To:	Department of Planning & Environment
From:	Colliers International Engineering & Design
Date:	12 th December 2023
Subject:	Re: Planning Proposal – Patyegarang Morgan Rd Belrose – Sydney Water response

**Response to Key Submissions – Patyegarang Planning Proposal
PP-2022-3802 – Post-exhibition**

RE: Planning Proposal Patyegarang (PP-2022-3802) - response to DPE (EHG) submission dated 21 November 2023

Re: Response to Flooding Related Comments from Environment and Heritage Group (EHG)
Regarding Planning Proposal Patyegarang (PP-2022-3802)

FIGURE 1 REGIONAL FLOOD FREQUENCY ESTIMATION GRAPHICAL RESULTS WITH 5% AND 95% CONFIDENCE LIMITS

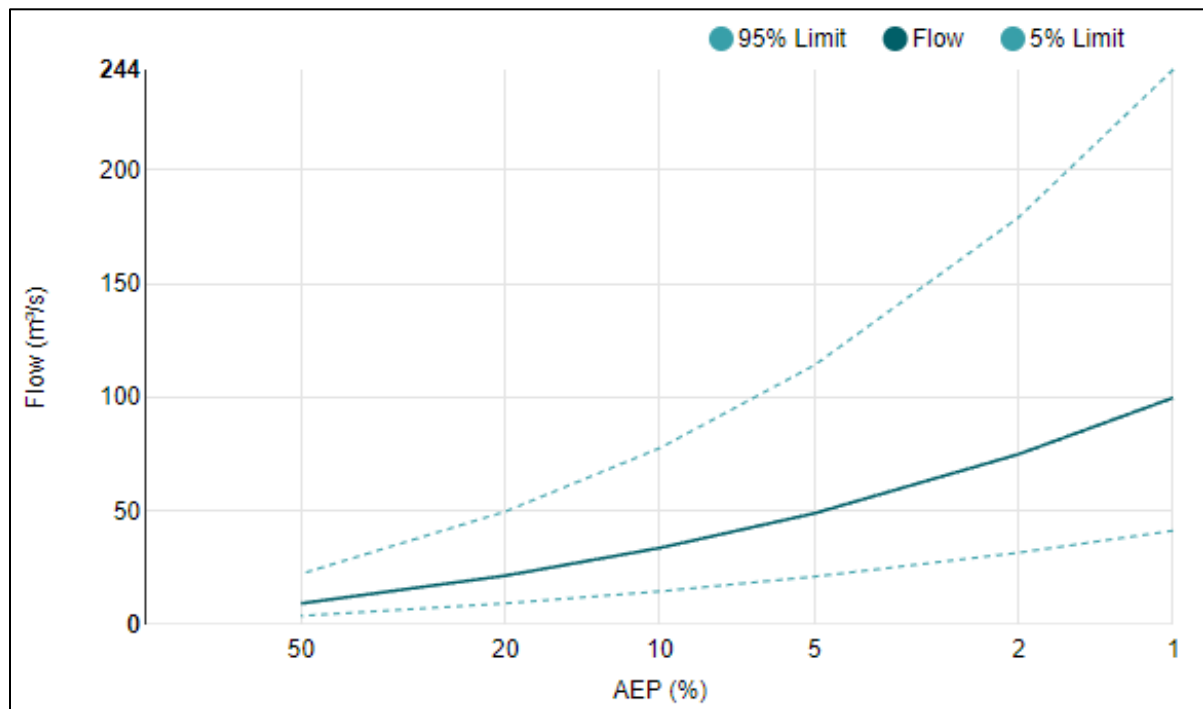
TABLE 1 HYDROLOGICAL VALIDATION (CL = CONFIDENCE LIMIT)

Validation Location	Calculation Method	Flow (m ³ /s)
Snake Creek Outlet from Site Catchment	XP-RAFTS	71.7 (25 minute storm duration)
	RFFE	99.7 5% CL =41.3 95% CL = 244
	Rational Method	34.32
